Oregon Structural Specialty Code

2025 edition

The following is errata for the published 2025 Oregon Structural Specialty Code (OSSC).

Figure 1808.7.1—Foundation clearances from slopes

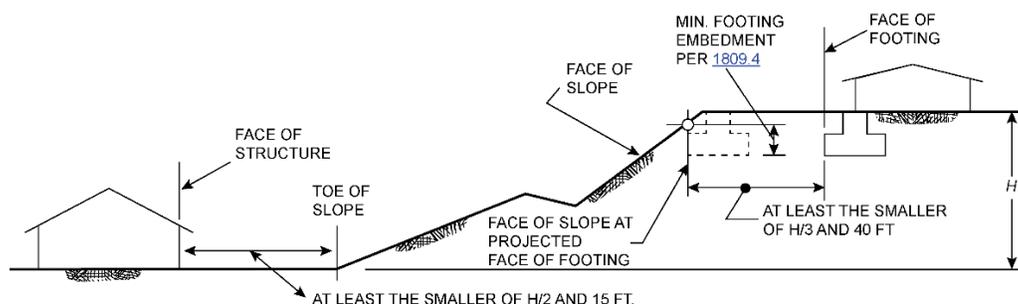
Chapter 18 Soils and foundations
